From: Kristen Kapelanski, AICP
Date: 7/9/2019
Re: **Cumberland Village (City File #17-019)**
Final Site Condominium Plan - Planning Review #2

From: Paul G. Shumejko, P.E., PTOE Transportation Engineering Manager
To: Kristen Kapelanski, AICP, Manager of Planning
Date: July 12, 2019
Re: Cumberland Village, City File #17-019, Section 27
Revised Final Site Condominium Plan Review #1

To: Kristen Kapelanski
From: Matt Einheuser
Date: April 26, 2019
Re: Cumberland Village – Review #1 FSCP
File #17-019

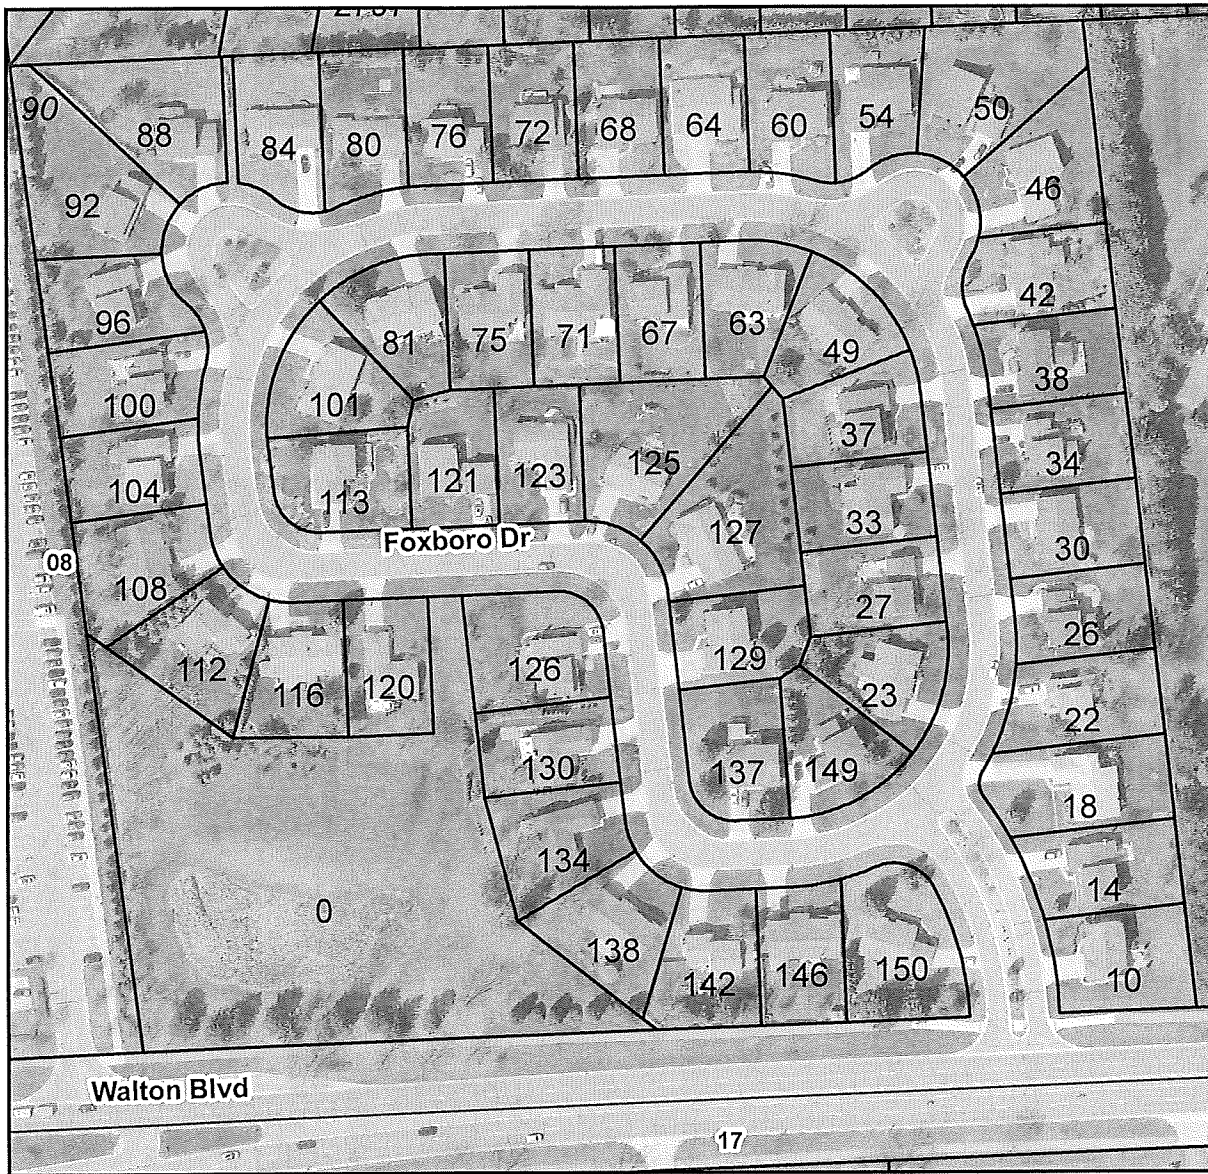
Option 2 – Right-in/Right-out Only (RI/RO)

- When warranted, RI/RO entrance configurations are typically constructed at commercial type driveway approaches and generally not at public or private street entrances.
- Non-compliance rates for RI/RO drive approaches can be high. At commercial site developments, motorists often disregard the RI/RO traffic control devices.
- Typically requires additional enforcement by the Oakland County Sherriff Office (OCSO) to garner compliance, which can be an issue with limited resources available.
